VILLAGE OF MONROE
Workshop Minutes
August 11, 2025

Site Plan Review – Proposed addition / Condos

581 Route 17M - Monroe Pharm Plaza Condo (220-5-16.312)

Subject: 581 State Route 17M Site Plan Review

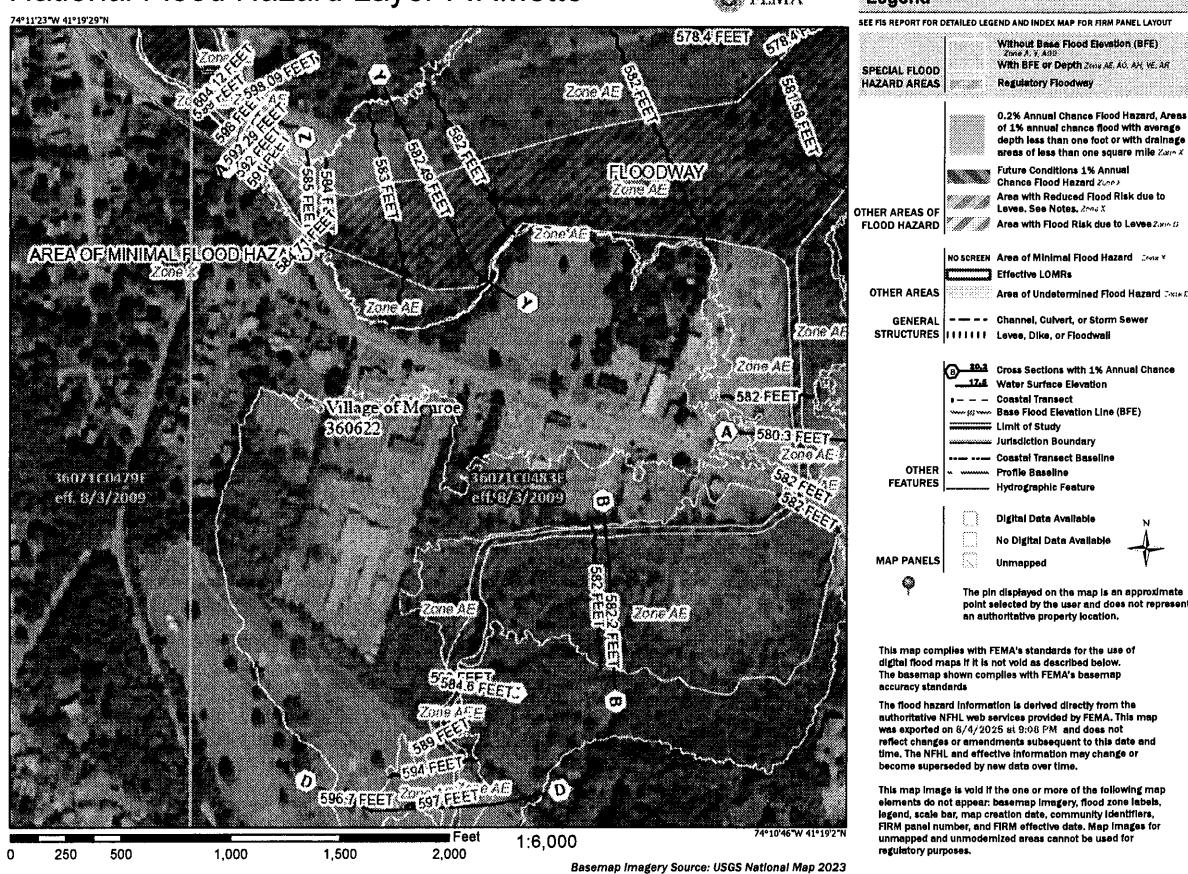
6. Section 200-32 of the Zoning Law provides requirements for a tree and landscaping plan including planting requirements at 200-32F. The landscape planting requirements are most applicable since the site has little if any existing vegetation. Sheets 4 and 5 provide for "Landscaping and Lighting Plan" and for "Landscape rendering" respectively. Both sheets should be updated to comply with the requirements of Subsection F. In addition, Sheet 4 shows a Plant List that includes 4 Red Maple and 3 Honeylocust. I was unable to locate anywhere on the site where these seven trees were

proposed for planting.

National Flood Hazard Layer FIRMette

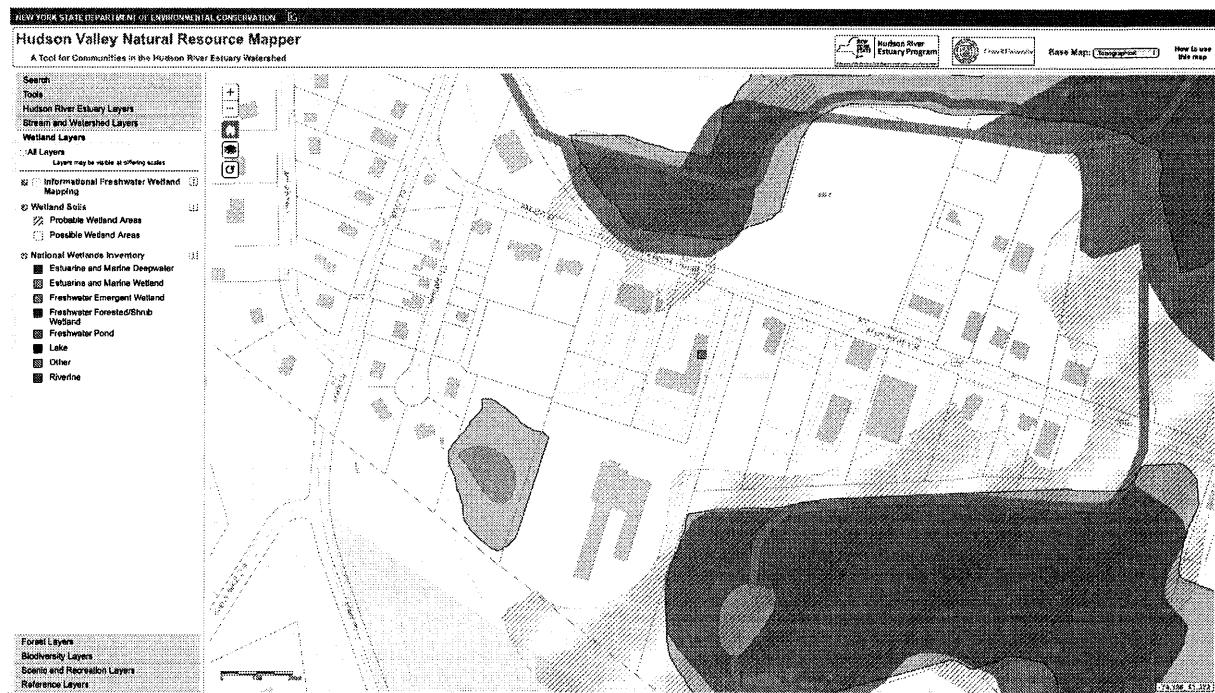
3. **FEMA Flood Designation.** The project site is not within a FEMA mapped 100 year floodplain and is not regulated under Chapter 107 of the Village Code, Flood Damage Prevention. However, a considerable portion of the site is located within a designated 500 year floodplain as shown on the attached FEMA "National Flood Hazard Layer FIRMette" map. The proposed third building has been sited entirely within the designated 500 year floodplain. I recommend that the proposed location of the third new office building be "flipped" from attachment to the existing southernmost building to attachment to the existing northernmost building facing the street. If placed in this area, a portion of this new proposed building would still be partially located within the 500 year floodplain but much of it could be located outside of this area. It should be noted that both of the existing buildings are within the designated 500 year floodplain. If relocated on the site, the proposed new building's dimensions could substantially match the size and configuration of the proposed third building in its present proposed location while still complying with the minimum 60 foot front yard and side yard setback requirements found in the Zoning Law's Table of District Uses and Bulk Regulations for the GB District. There are a number of benefits to revising the Site Plan in this manner as follows:

- a. **Storm Frequency.** The frequency of 500 year flood events has been increasing. According to [CBS News](#), there have been 24 or more 500 year flood events in the US since 2010. Accompanying this increase has been an increase in large storms between 1980 and 2024 causing an increase in the costs of damage attributed such events, as documented on the attached graphic from the National Oceanic and Atmospheric Administration's (NOAA) National Centers for Environmental Information. Locally, in Highland Falls (and nearby Cold Spring), a flash flood occurred in July 2023 that was only the second flash flood event ever recorded in Orange County. Governor Hochul and others stated that the Highland Falls flood was a [1,000 year flood event](#). The first flash flood event was the result of Hurricane Ida in 2021, which caused 18 deaths in New York State, according to the [New York Times](#). The third new building is proposed to have a basement, which would likely flood in a severe storm event.

- b. **Zoning.** An established purpose of the Village Zoning is: "*Providing adequate privacy, light and air and securing safety from fire, panic, flood and other dangers.*" [emphasis added, see Village Zoning § 200-2.D]. Section 200-72.I.(1)(b)[24] also requires that site plans "*shall contain...Designation, location and elevation of lands in a floodway or subject to periodic flooding*" [emphasis added] without regard to whether such lands are subject to designated 100 year or 500 year floods. Designation as a 500 year floodplain means the project site is subject to periodic flooding.
